# MEMO

**To:** Kristopher Byrd, Well Construction Manager  
**From:** Tommy Laird, Well Construction Program Coordinator  
**Subject:** Review of Water Right Application G-19039  
**Date:** February 20, 2024

# Groundwater Application Review Summary Form

Application # G- 19039

**D. WELL CONSTRUCTION, OAR 690-200**

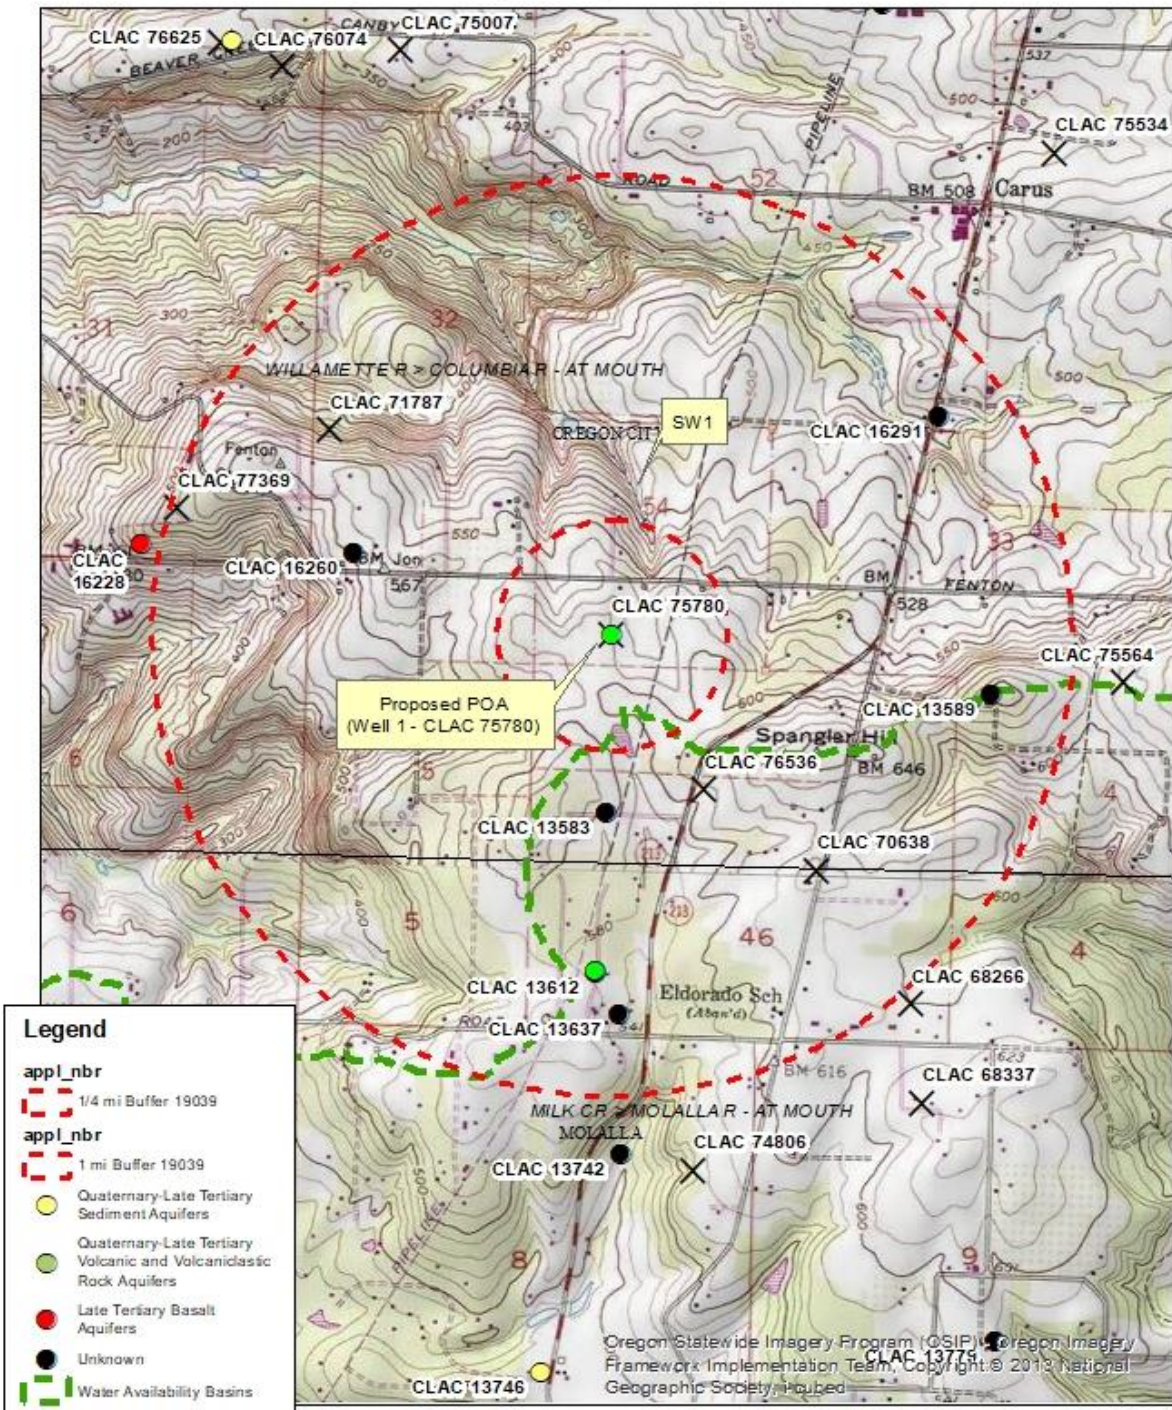
D2. **THE WELL does not appear to meet current well construction standards based upon:**

D3. **THE WELL construction deficiency or other comment is described as follows:** \_\_\_\_\_  
\_\_\_\_\_  
\_\_\_\_\_  
\_\_\_\_\_

D4.  **Route to the Well Construction and Compliance Section for a review of existing well construction.**
